GUNNEDAH RECYCLING & RESOURCE RECOVERY FACILITY SSD-8530563

LOTS 1 & 2 DP 1226992, No. 16 TORRENS ROAD & No. 17-21 ALLGAYER DRIVE,
GUNNEDAH NSW

Amendment Report

FIGURE 3.2: The proposed facility, as amended

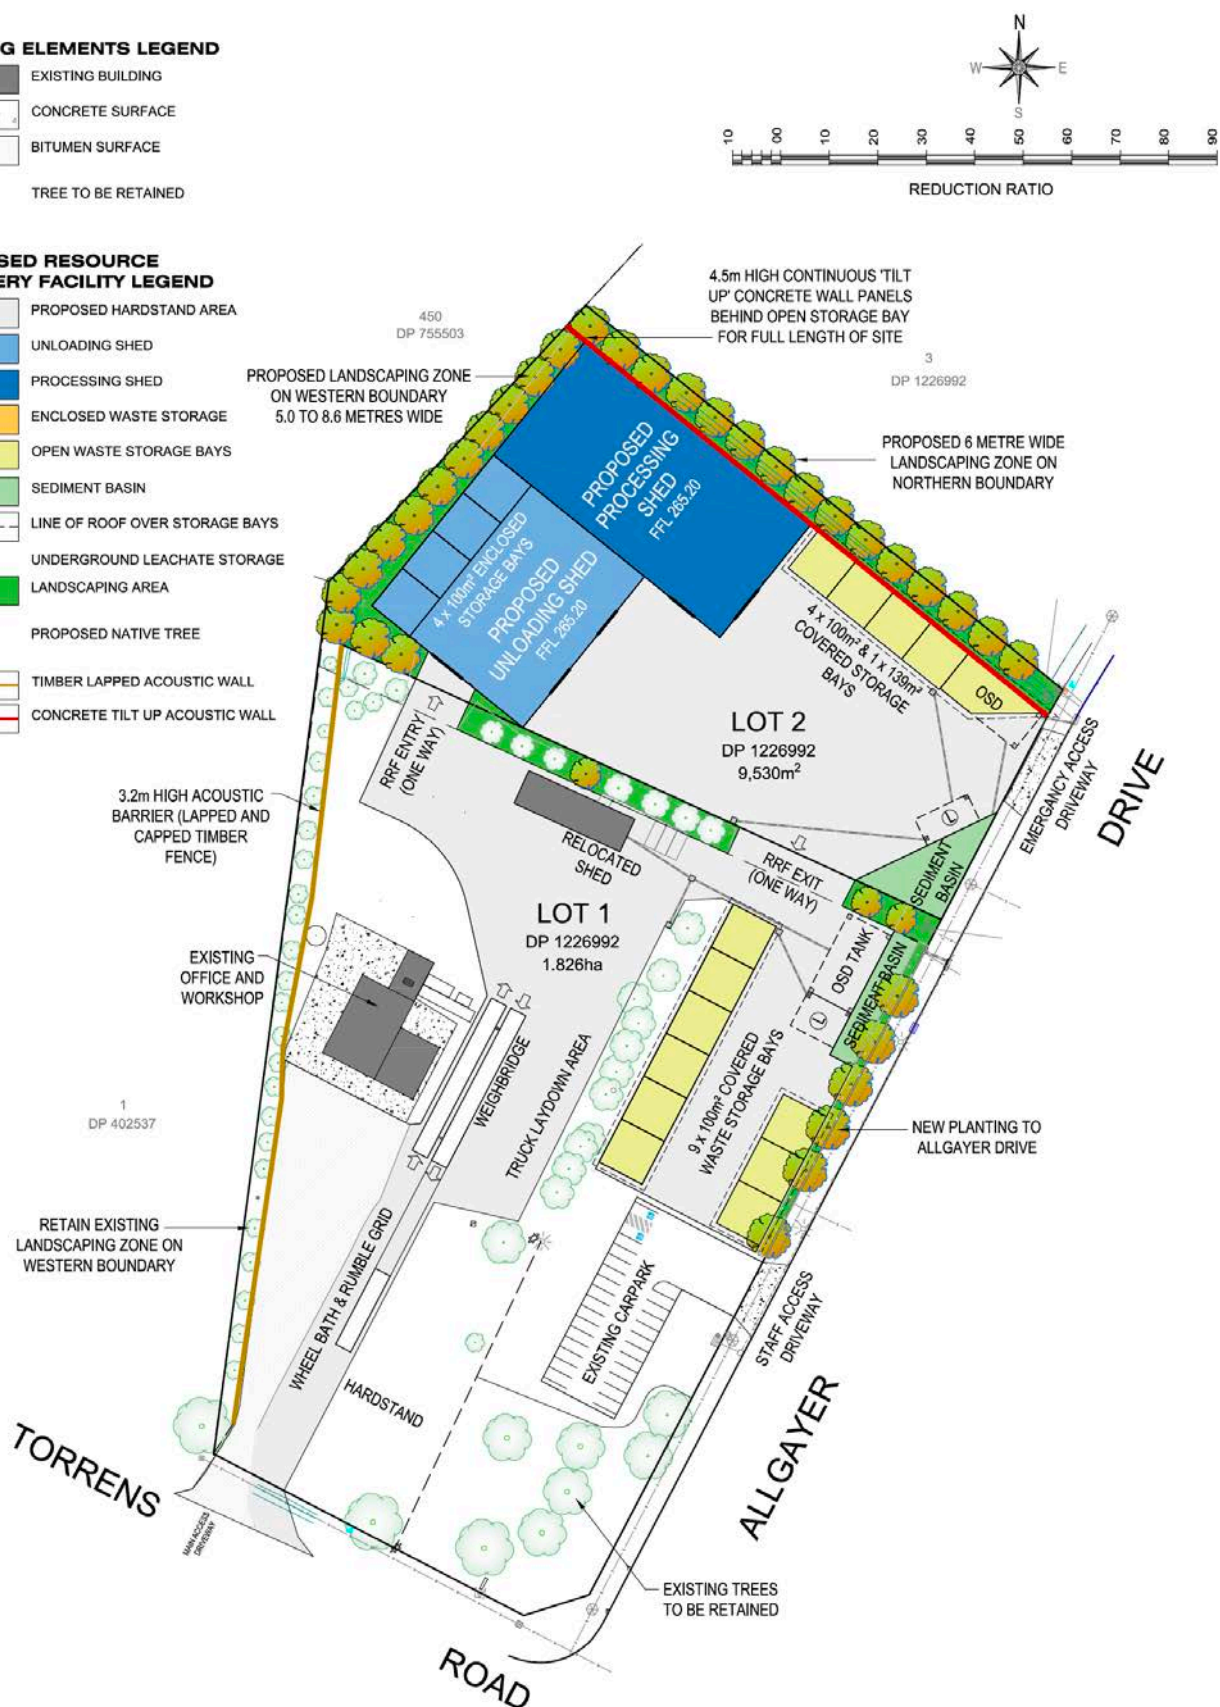
- No asbestos (special waste) or lithium batteries (hazardous waste) will now be accepted at the project site, including the storage of these wastes on site. Accordingly, the restricted waste shed no longer forms a part of the project, given that there will be no longer a need to provide for a building specifically dedicated to the storage of such wastes.

Further minor revisions are sought to the design of the project, in the main, in response to either community concerns or queries raised by the Department. A high-level summary of the material elements of the project is presented in Section 3.2 below together with a comparison of the proposed project, as amended. The accompanying **Figures 3.1** and **3.2** compare the original project, as exhibited, with the project, as amended. The amended development, incorporating the changes sought, are essentially the same as that originally proposed.
